SUBJECT: Safety Recall 01S26-S1:
Certain 1999, 2000 and 2001 Model Year Windstar Vehicles
Auxiliary Rear A/C Blower Wiring

REFERENCE: Safety Recall 01S26, dated August 15, 2001

REASON FOR THIS SUPPLEMENT

The Assembly Plant has advised that some vehicles produced from December 4, 2000 through December 16, 2000, may have been repaired before they were shipped. This supplement adds a dealer inspection process to identify these vehicles.

FIGURE 1

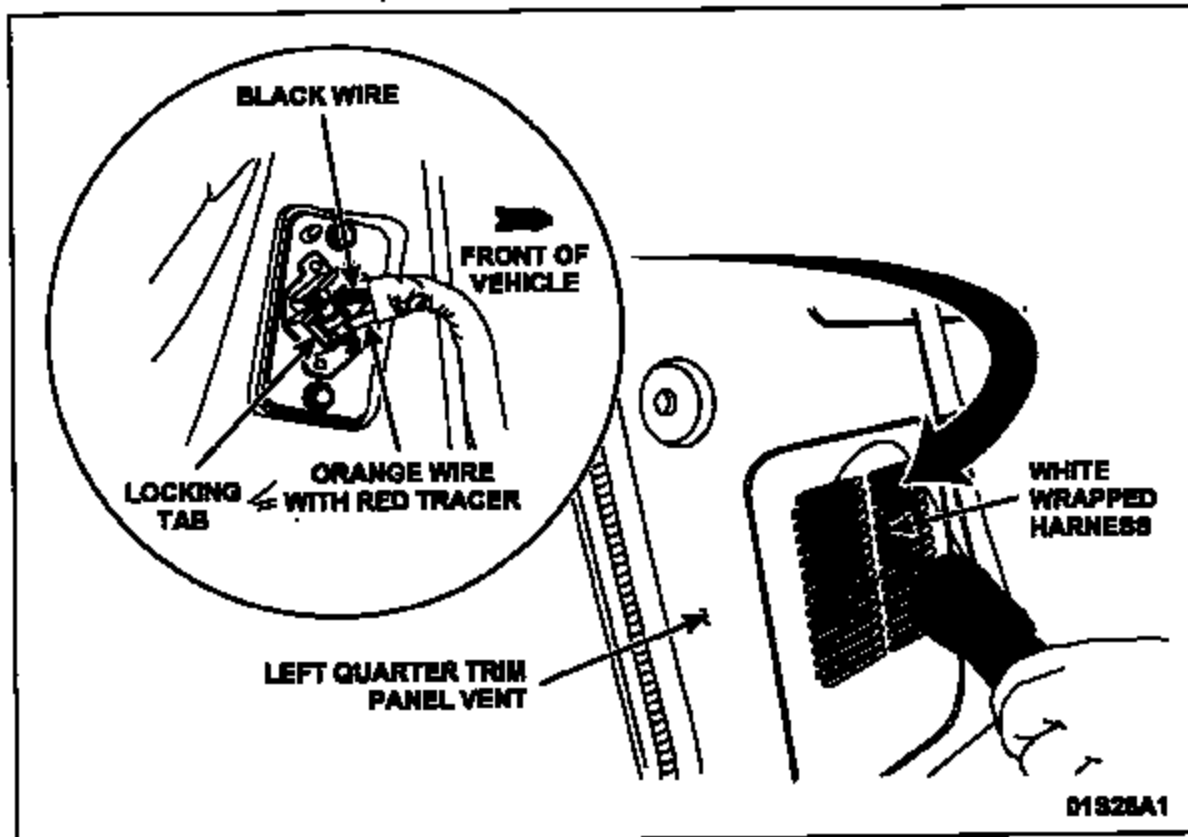
1. Open the liftgate and look through the left quarter trim panel to verify that the auxiliary blower motor wire harness has a white-colored wrapping.
 - If the white wrapping is present, the vehicle does not need to be repaired.
 - If the white wrapping is not present or not visible, use a flashlight to verify that the auxiliary blower motor electrical connector has a black wire installed to the left of the connector locking tab. There will be an orange wire with a red tracer to the right of the locking tab. See Figure 1.
 - If the black wire is present, the vehicle does not need to be repaired.
 - If the black wire is not present, the vehicle must be repaired.

FIGURE 2

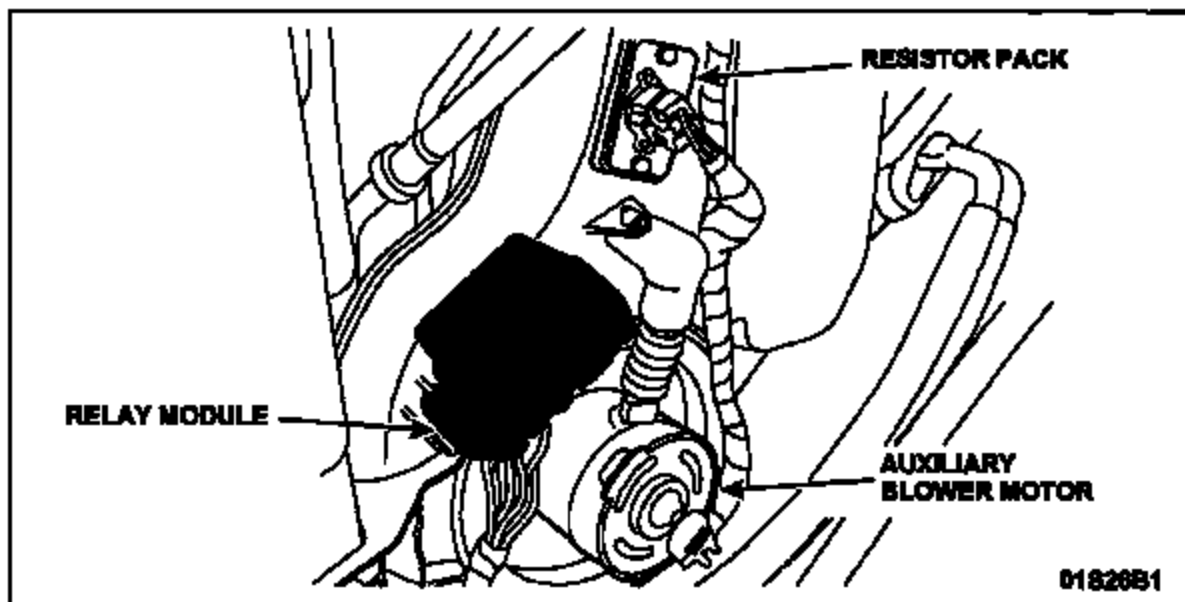
12. Remove the relay module located above the blower motor. See Figure 2.

FIGURE 3

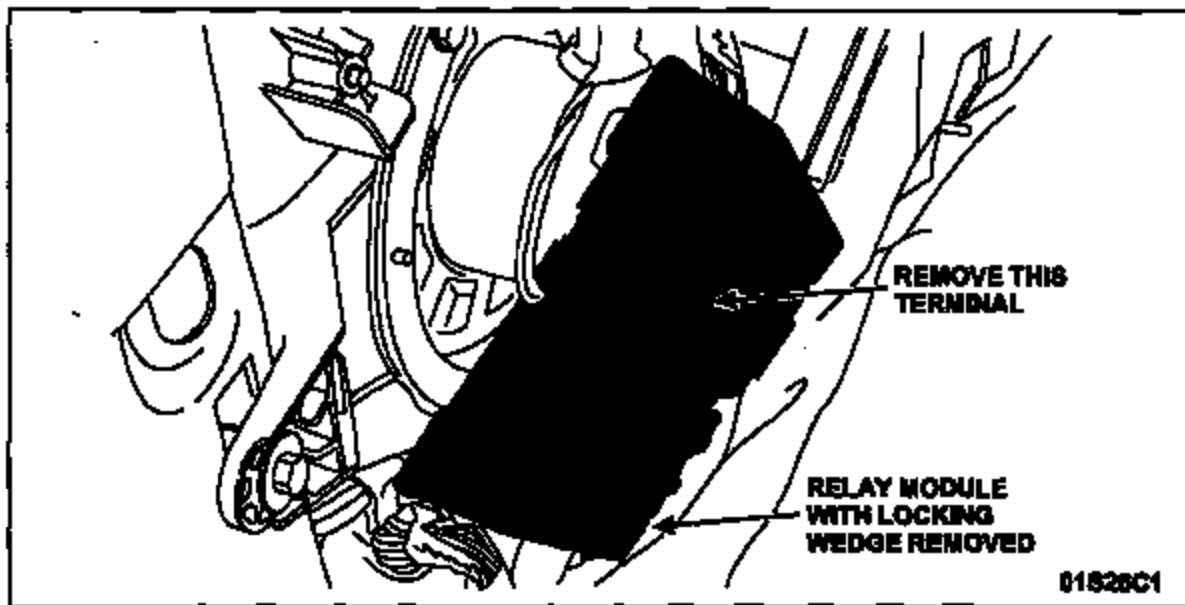
13. Remove the relay module cover and both relays from the module. Then remove the relay module locking wedges. See Figure 3.
14. Remove the black wire and terminal from the relay module using a small screwdriver, or similar pick tool, to depress the terminal locking tab. See Figure 3.

15. Cut the terminal end off the black wire, wrap the wire end with electrical tape to insulate the wire, and then tape the wire to the harness.

FIGURE 4

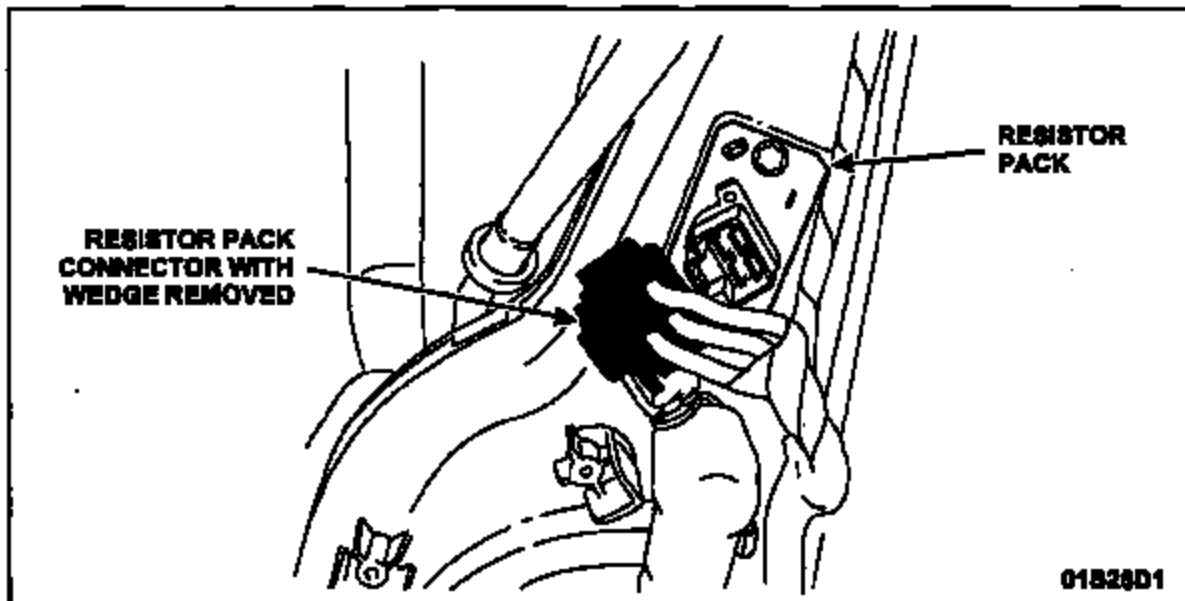
16. Disconnect the auxiliary blower motor resistor pack connector, and remove the locking wedge from the connector. See Figure 4.

FIGURE 5

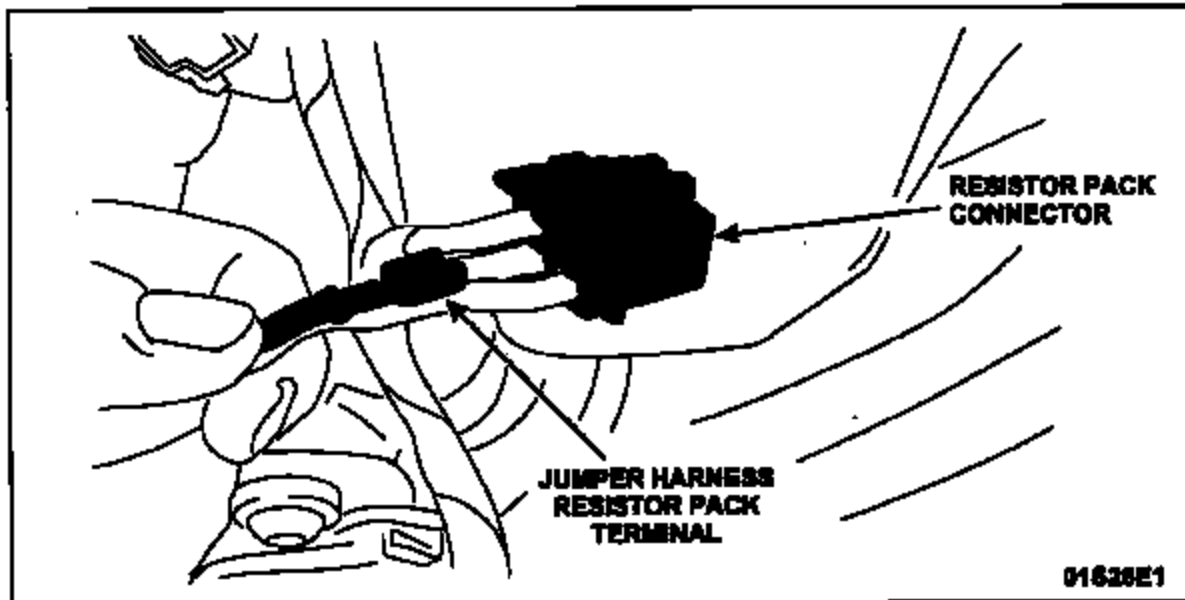
1. **CAUTION:** The terminals on each end of the jumper harness are different. Make sure to match the correct terminal to the correct connector before installation. The end of the jumper harness with the identification tag goes into the resistor pack connector.

Insert the end of the jumper harness with the identification tag into the resistor pack connector. Lightly pull on the jumper harness to ensure that the terminal is locked into the connector, and install the locking wedge onto the connector. See Figure 5.

2. Reconnect the auxiliary blower motor resistor pack connector to the resistor pack.

FIGURE 6

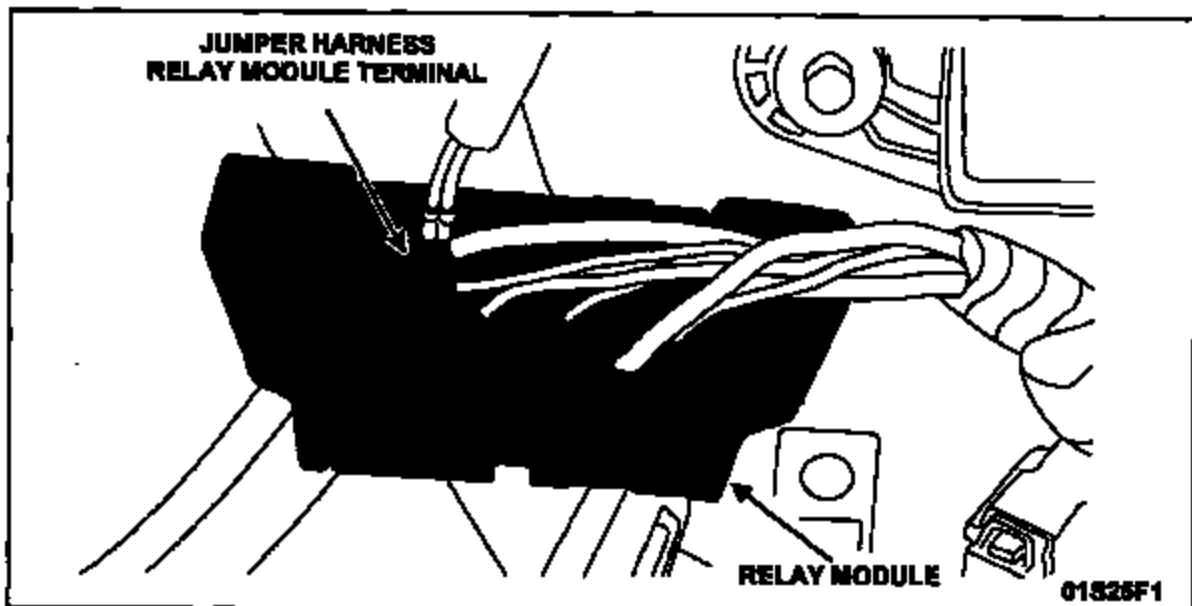
3. Insert the opposite end of the jumper harness into the cavity of the relay module from which the black wire was removed. Lightly pull on the jumper harness to ensure that the terminal is locked into the connector. See Figure 6.

FIGURE 7

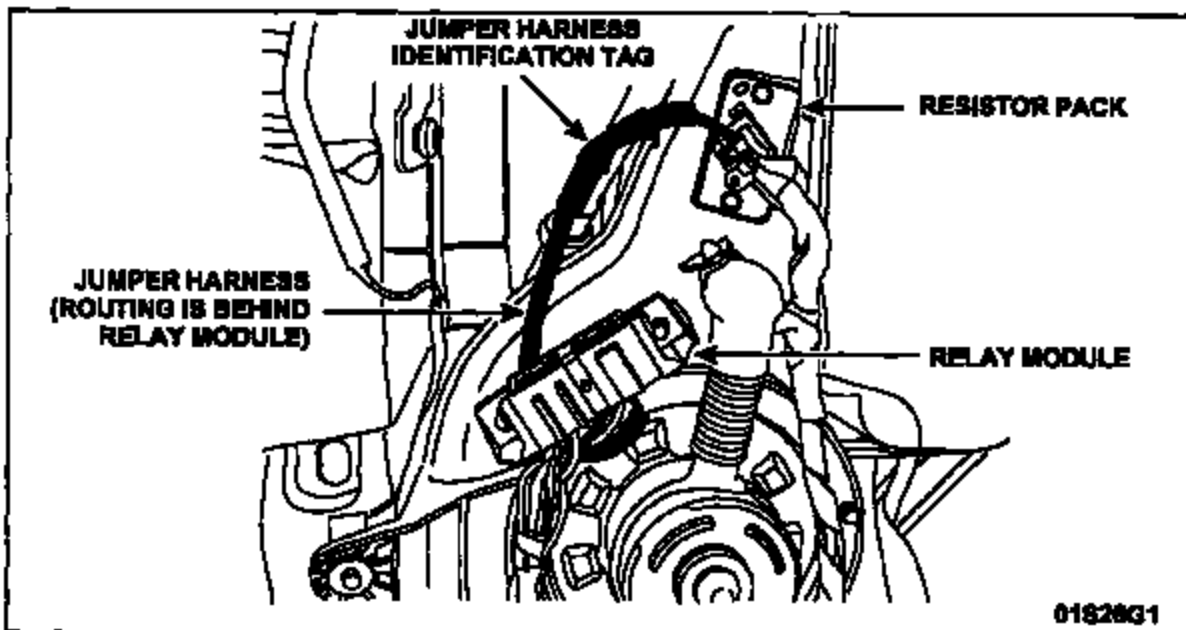
4. Install the relay module locking wedge into the relay module. Install both relays and install the cover.
5. Route the jumper harness behind the relay module before installing the module. See Figure 7.

6. Install the relay module into its original position above the blower motor.
7. Connect the battery negative cable and remove the memory saver.
8. Verify that the auxiliary blower motor operates correctly at all speeds.
9. Position the quarter trim panel in the vehicle.
10. Install the two (2) pushpin retainers by the floor, then install the pushpin retainer by the C-pillar (four-door model only).
11. Install the two (2) quarter trim panel screws by the liftgate.
12. Install the D-pillar trim panel.
13. Install any pushpin fastener(s) or screw(s) that secure the D-pillar trim panel.
14. **WARNING: BE SURE TO TIGHTEN THE SEAT BELT ANCHOR BOLT TO THE PROPER TORQUE SPECIFICATION.**
